**AGENDA FOR REGULAR MEETING
VILLAGE OF TINLEY PARK
PLAN COMMISSION
May 7, 2015 – 7:30 P.M.
Council Chambers
Village Hall – 16250 S. Oak Park Avenue**

**Item #1 BRIXMOR OUTLOT – 15917 S. HARLEM AVENUE – SITE PLAN APPROVAL
AND A SPECIAL USE FOR A SUBSTANTIAL DEVIATION TO THE TINLEY
PARK PLAZA PLANNED UNIT DEVELOPMENT**

PLAN COMMISSION STAFF REPORT

The Applicant, Jeff Slavish, for Brixmor, seeks approvals for the proposed Site Plan and a Special Use for a Substantial Deviation of the approved Tinley Park PUD. The Applicant proposes to demolish the northern 7,290 SF of the in-line tenant spaces (former Outrigger Restaurant) and develop a one-story 9,100 SF multi-tenant retail building and related site improvements.

Area 1

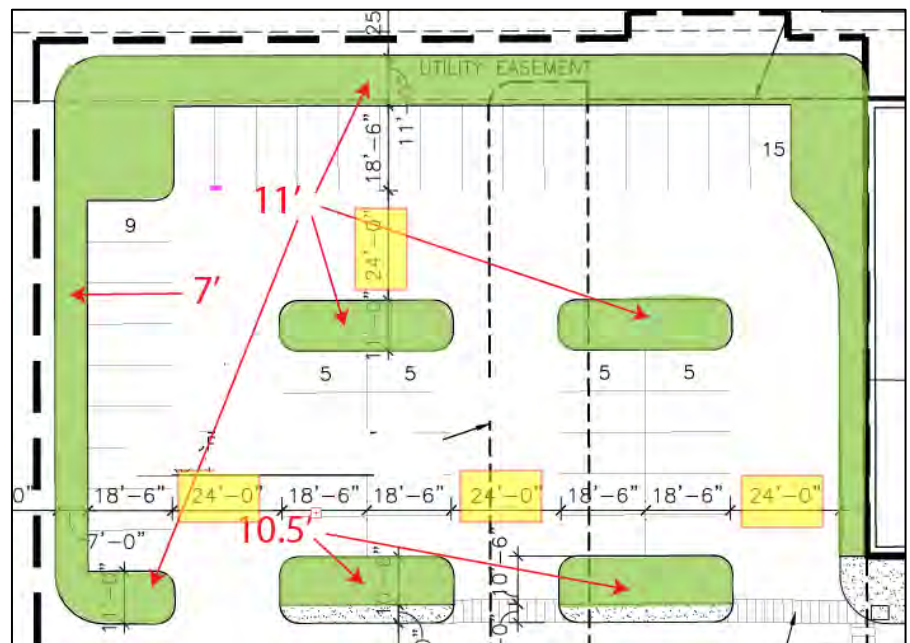
The Applicant has provided a revised plan that addresses the bufferyard, parking island width and parking lot screening concerns of the previous submittal. The east side of the parking which will function as the east bufferyard has been increased from 7' to 11', which exceeds the bufferyard minimum requirement. The four (4) landscape islands have been increased to also exceed ordinance requirements and measure 10.5' and 11' in width, thus eliminating the deficient parking island widths of the previous proposal.

The north edge of the parking will serve as the bufferyard for this property since there is no availability north of the east-west access drive bordering this parking lot. A type 'B' bufferyard is required with a minimum width of 5'. A 7' bufferyard has been provided; this is 1' greater than the original proposal. This will provide adequate planting area especially in light of the car overhang.

The limiting dimension for this lot configuration is the north-south dimension, therefore the parking lot aisles measure 24' in width (ordinance requires 26'). Staff is supportive of this request in light of the lot configuration and the additional landscaping that has been provided to mitigate the impact of the parking field.

Area 2

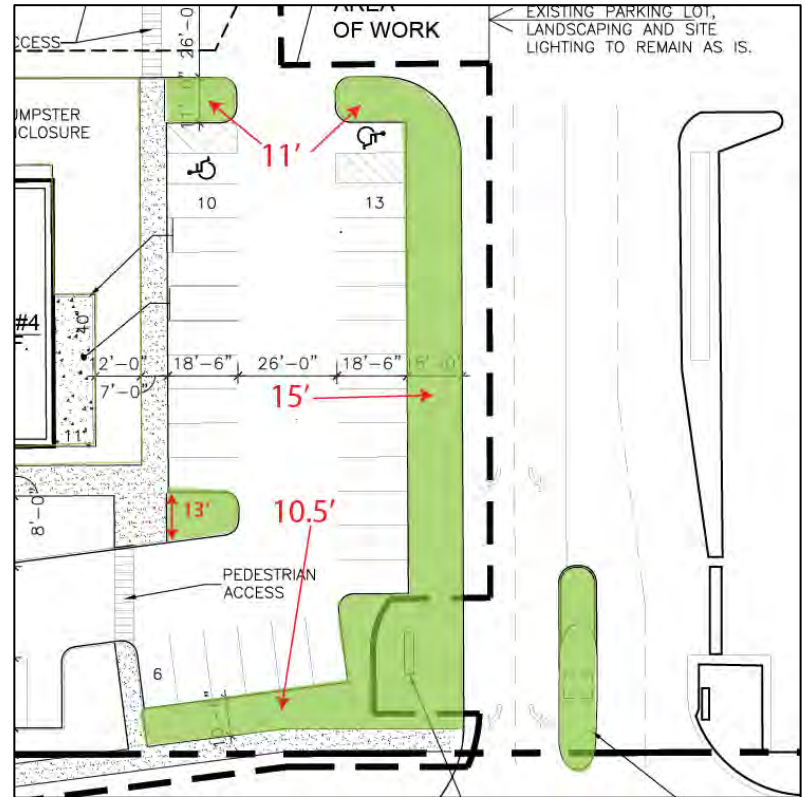
Area 2 comprises the parking field to the south of the proposed multi-tenant structure and includes the entry boulevard from Harlem Avenue. The Applicant made significant revisions to the original proposal resulting in improved circulation, decreased points of conflict with the main drive aisle, increased landscape island widths and has not met aisle width requirements. No exceptions to Village ordinance are required with this new proposal.

The proposed entryway boulevard continues to provide a four lane cross section with additional width provided at the intersection with Harlem Avenue. This will provide easier and safer access to the center and additional opportunity for landscaping. The existing landscaped island has been increased by 15' in length. Currently there is an exit from this parking area located at the southwest corner of the lot (close to the intersection) which has been eliminated for the improvement of circulation and access to the center.

The six (6') foot public sidewalk required along the Harlem Street frontage has been relocated out of the public ROW at the south end of the property due to the topography and deep drainage swale. The Applicant has agreed to record a public access easement for this encroachment onto their property. The revised plan provides a 10.5' bufferyard in this area (minimum required is 10') which will provide the necessary landscaping and will easily accommodate the bumper overhang for cars parked in this area. This is a significant improvement from the original proposal.

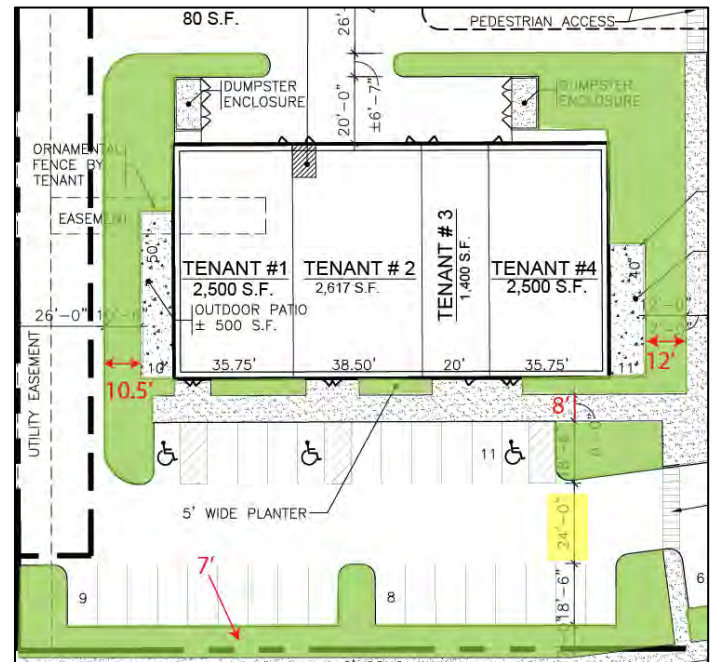
Area 3 encompasses the rear delivery and trash enclosure area and the front (west) façade of the proposed multi-tenant retail building. The Applicant has cooperated with staff and reduced the two points of access originally proposed at the rear of the building. This created additional greenspace and eliminated an unnecessary additional point of conflict with the main north-south access ("A"). The Applicant also agreed to move the building to the east and south which has provided additional greenspace (5' vs. 3' foundation planting) and adequate sidewalk width to accommodate bumper overhang (8' vs 5') in the front of the building. This also provided additional greenspace along the north side of the building (10.5' vs. 8') which will enhance the outdoor dining area in this location. Due to the recommended changes for the south lot,

additional greenspace was also provided along the south side of the building (12' vs. 8') which again enhances the outdoor dining area in this location.

A 24' drive aisle is proposed in front of the structure (26' required); the Applicant is requesting an exception to the Zoning Ordinance as part of the amendment to the PUD. This reduced aisle width is consistent with the aisle width for Tinley Square; a variation was granted for Tinley Square. Staff is supportive of this request in light of the lot configuration and the additional landscaping that has been provided to mitigate the impact of the parking field.

Open Item #4: Drive aisle does not meet minimum width requirements.

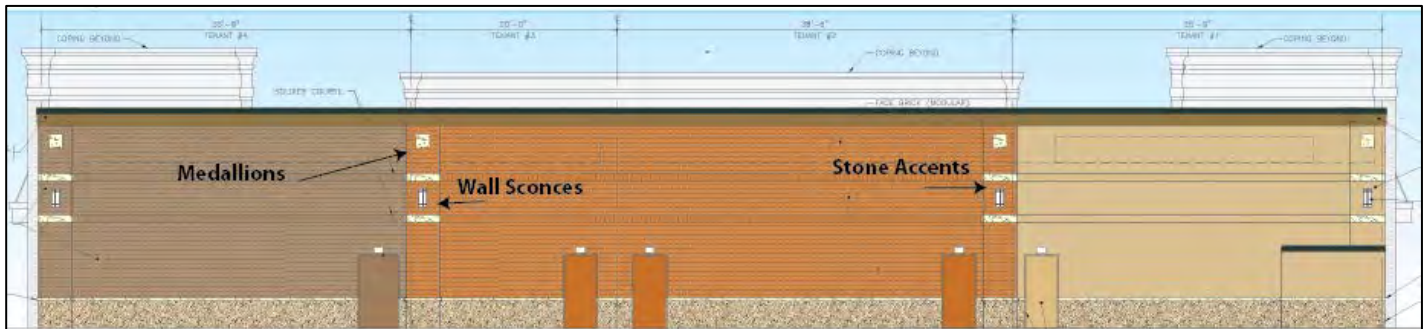
The Applicant has provided some additional architectural enhancements to the rear façade from what was originally proposed (which was lacking in architectural interest compared to the other facades). The Applicant has incorporated several of Staff's recommendations including a change in brick color that echoes the brick colors of the individual tenant spaces as seen on the west façade. A 4" reveal reflects a column element with stone accents and medallions have been added. These revisions along with the additional green space as recommended by Staff will help to mitigate the appearance of a "rear" façade.
